Re: Harold D. Thompson Regional Water Reclamation Facility (HDTRWRF)
Lower Fountain Metropolitan Sewage Disposal District (LFMSDD)

Submittal No.:	03200-009
Date of Submittal:	June 6, 2011
Title:	Foundation Plan & Base Slab Reinforcing for Secondary Clarifiers, Drawings P14, P15
Specification Section:	03200
Manufacturer:	Dalco Industries, Inc.

RE: P15

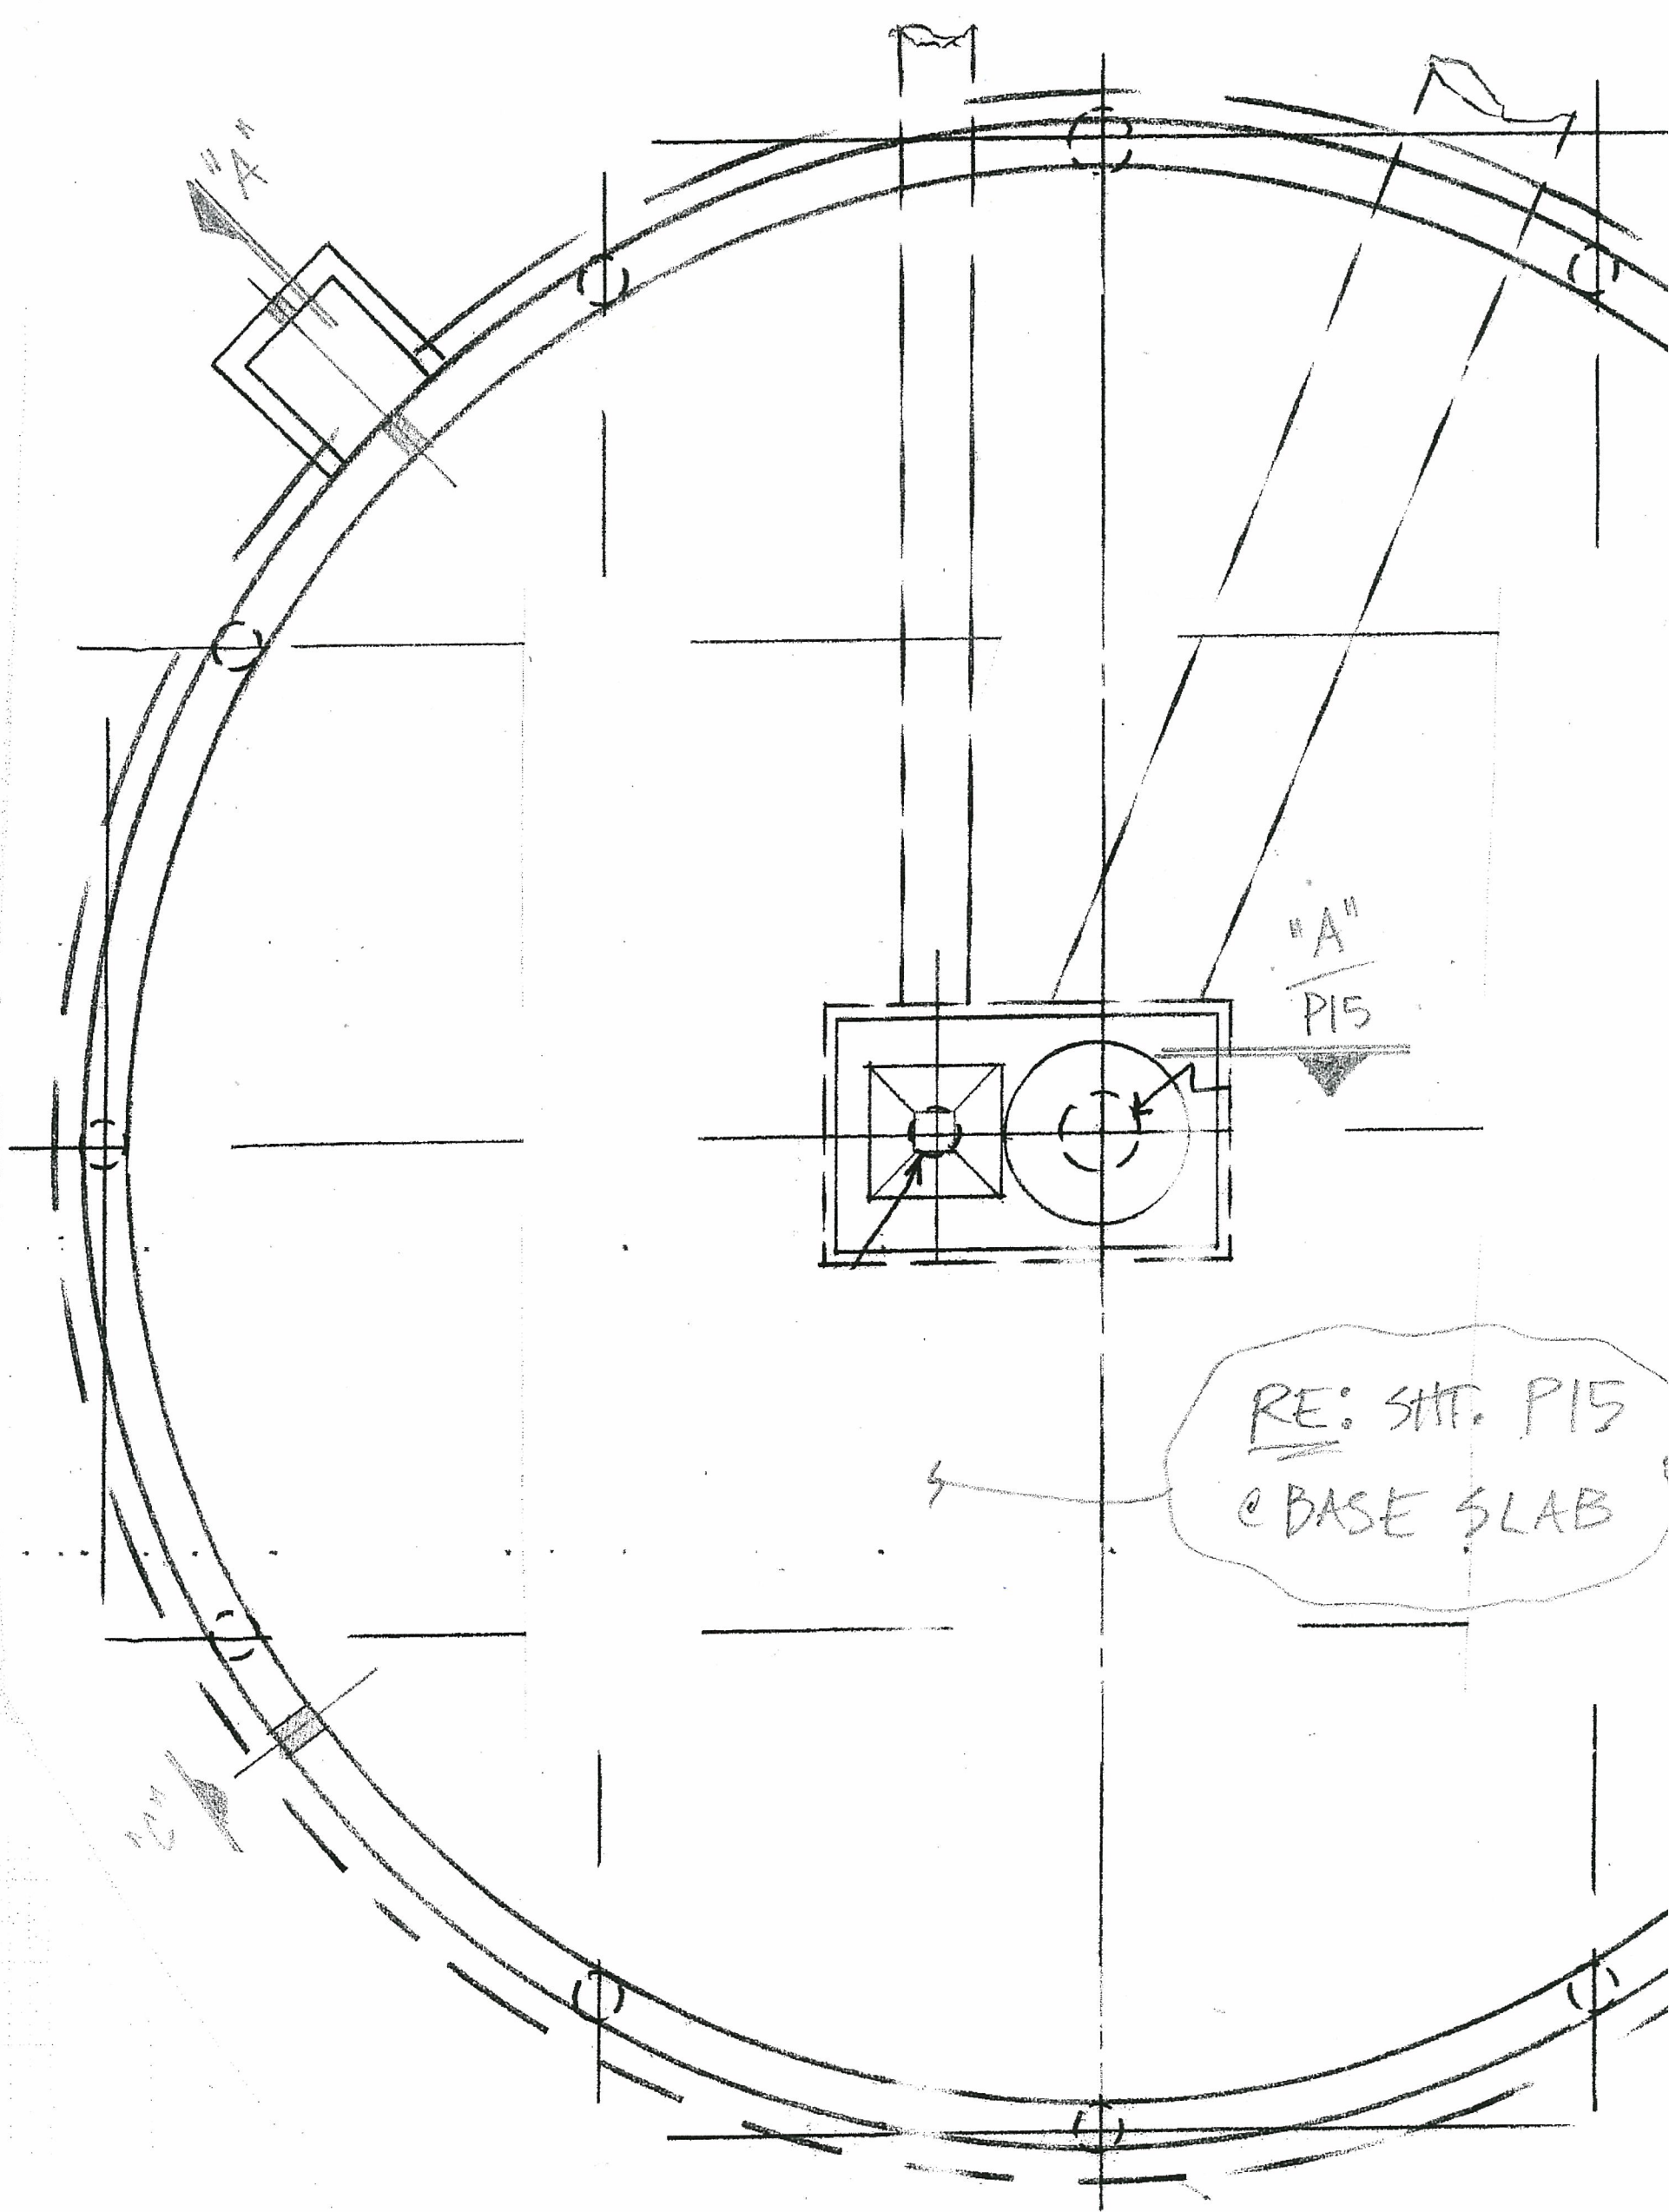
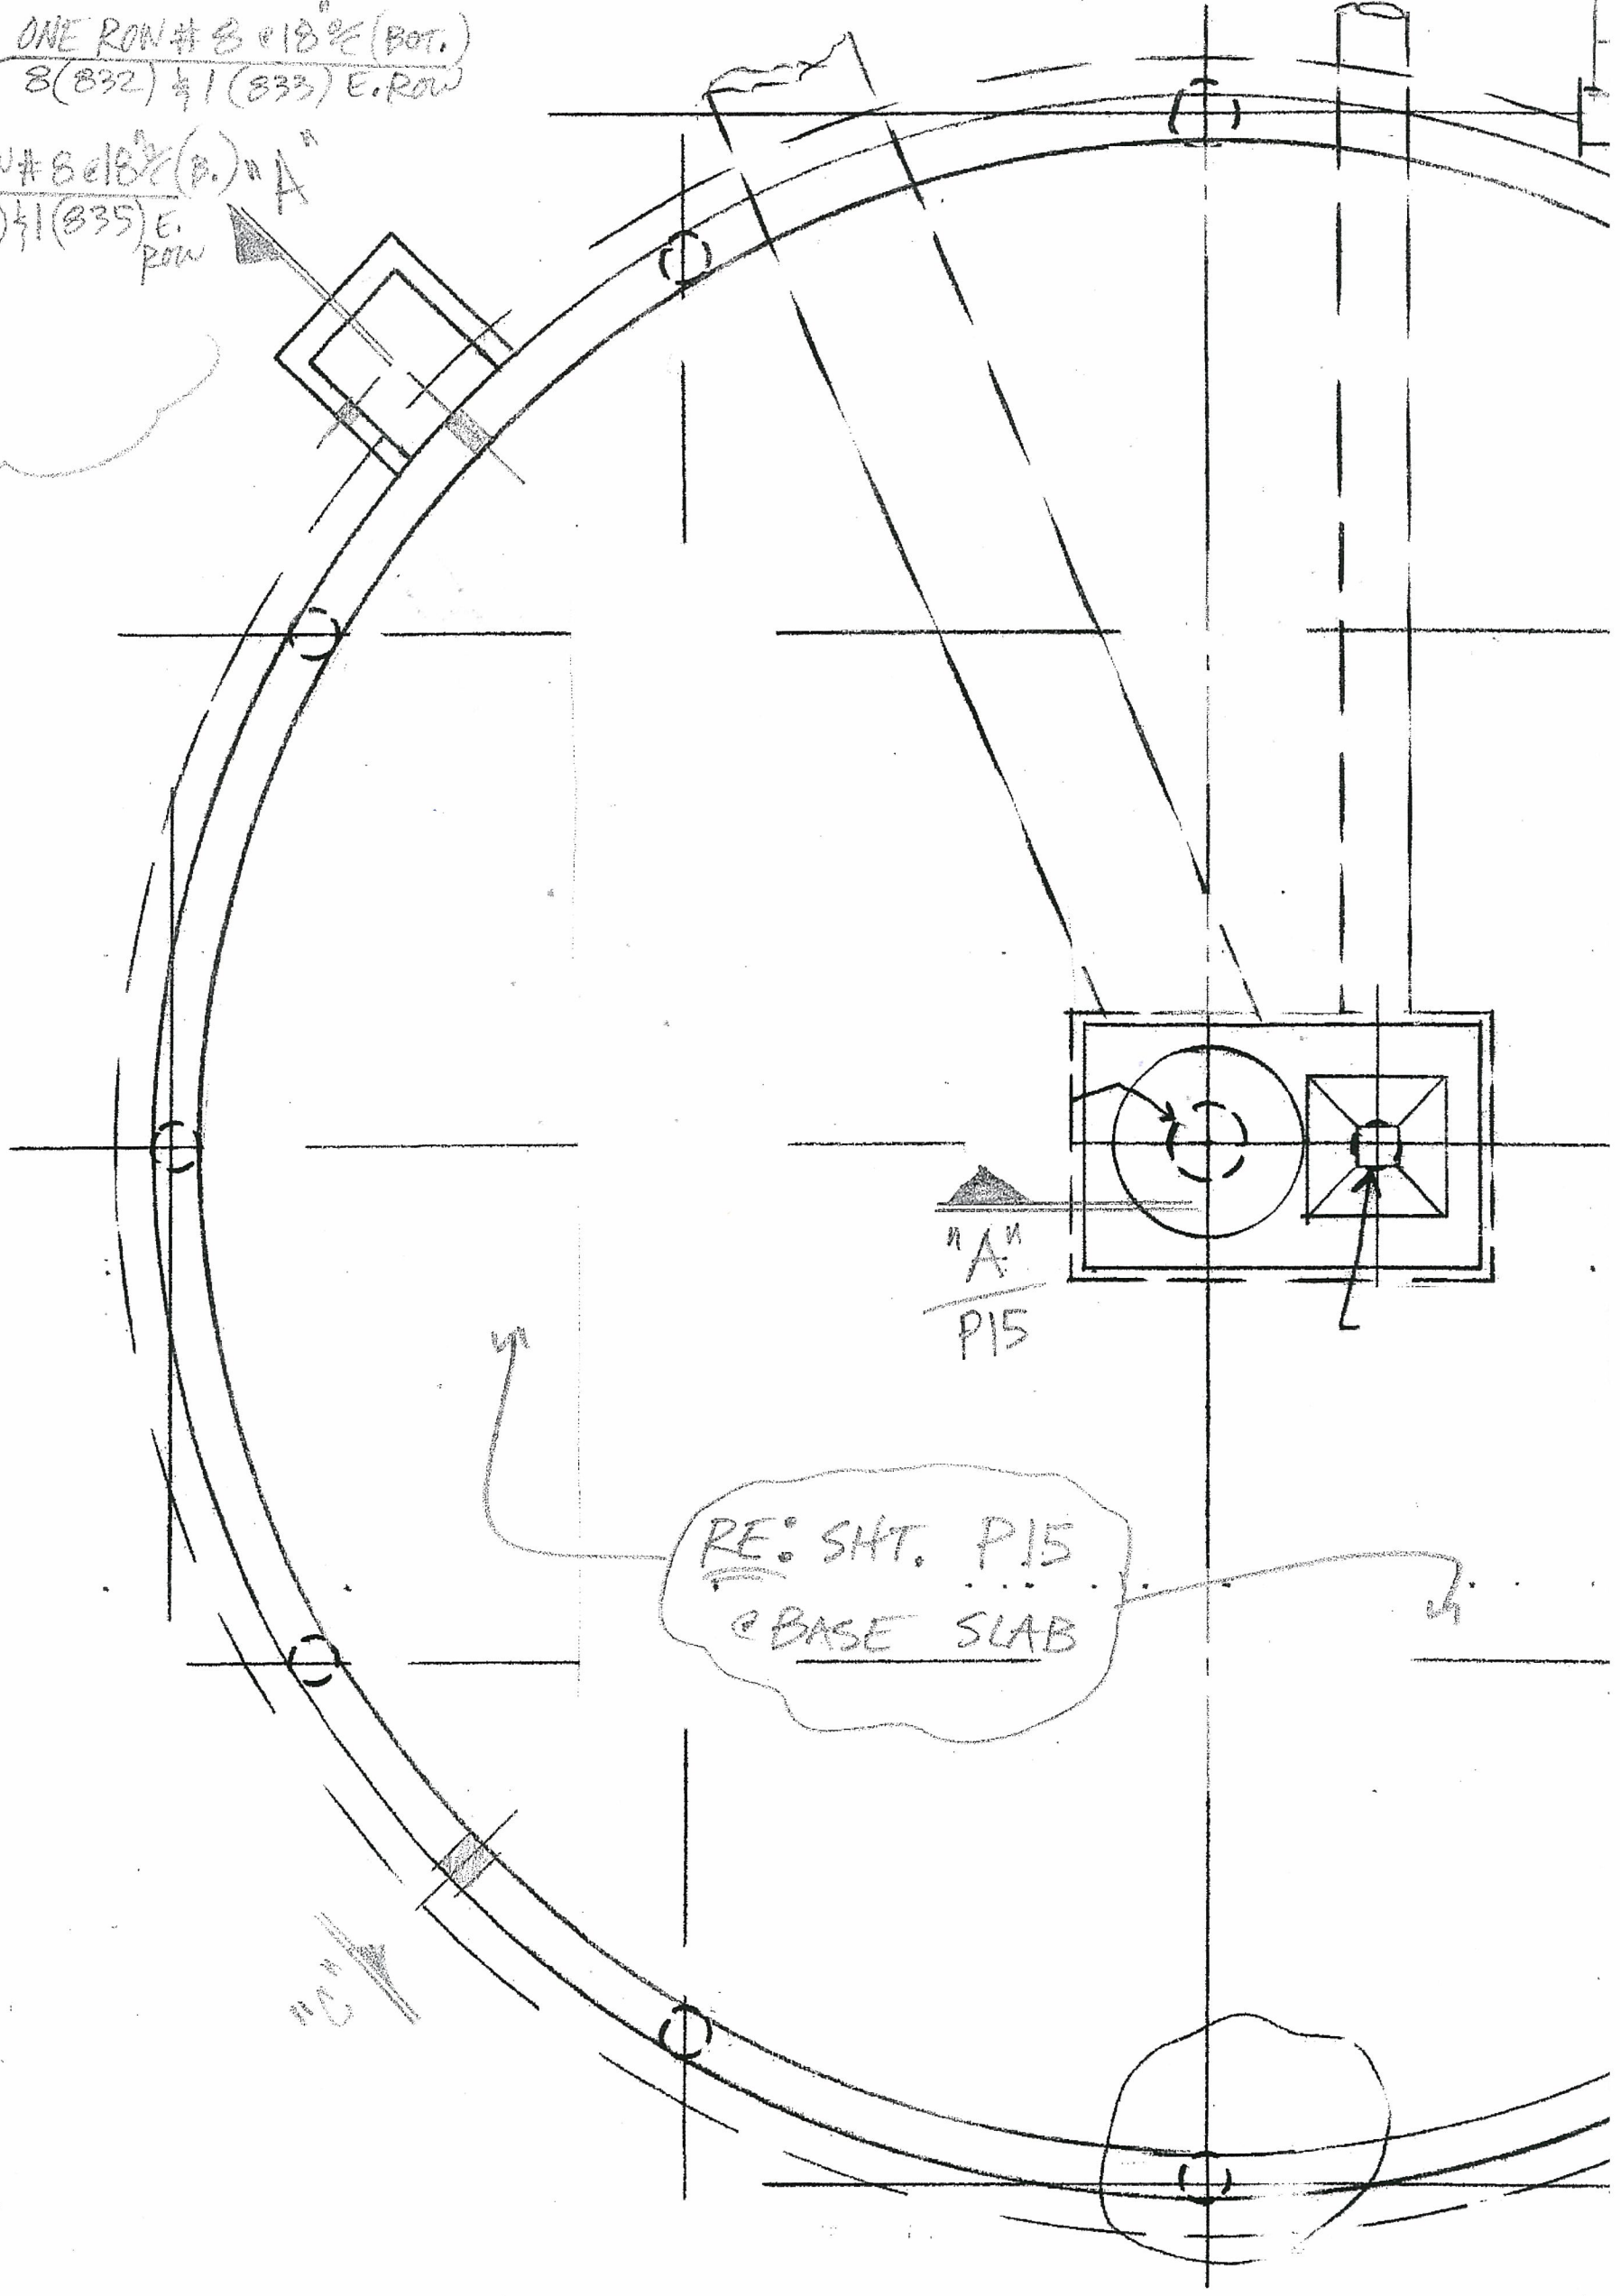
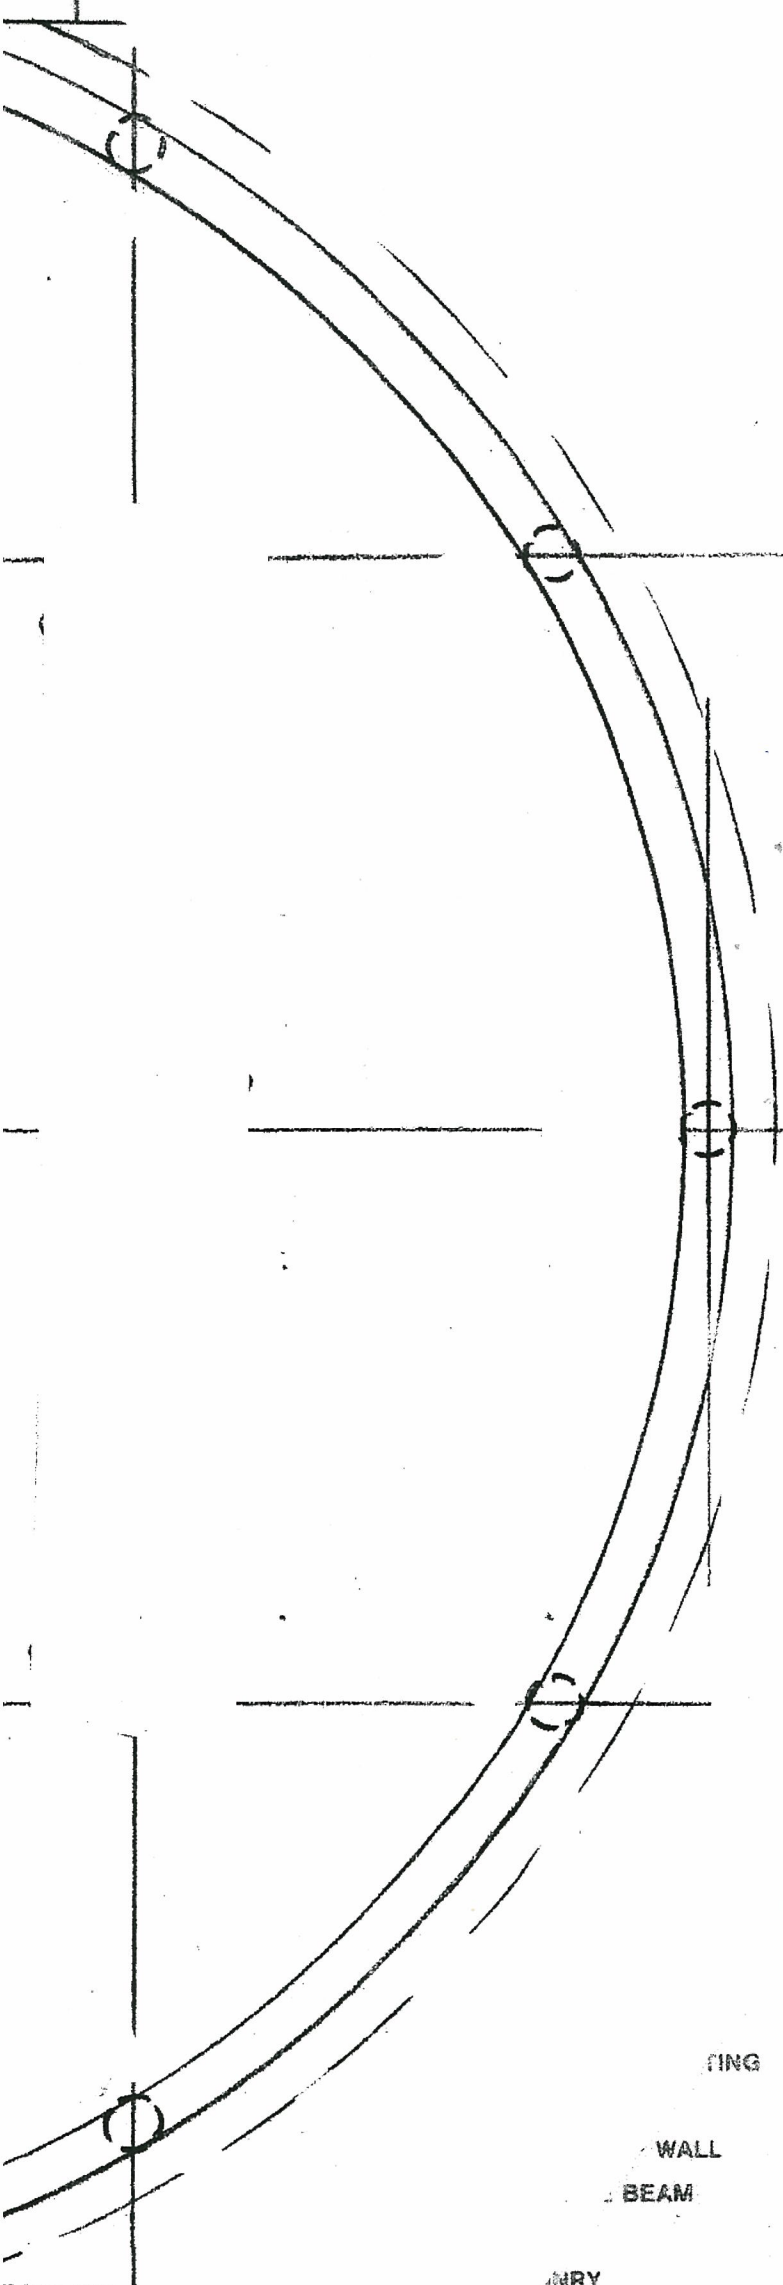
PLEASE ADVISE IF COUPLERS ARE AN OPTION

OK, SEE RFI #10

(X3) ? X4
VERIFY TOTAL # OF
PIPE PENE

REVISE BASED ON "B"- "C" / P-15

OK, SEE
RFI #10

1. Included with this letter are scanned copies of the submittal drawings P14 and P15 with handwritten comments in **red**. As these comments are relatively minor in nature, a complete resubmittal for these items is not required at this time. Please ensure that all handwritten comments are satisfactorily addressed prior to fabrication, delivery and placement of the reinforcing steel.
2. Please refer to RFI-010 delivered to WGCC on June 13, 2011 regarding dimensional information for dowels associated with the Form Saver installations.
3. Please closely coordinate with the clarifier equipment supplier to ensure that all required equipment anchors and/or embedments are installed in strict accordance with the supplier's instructions.
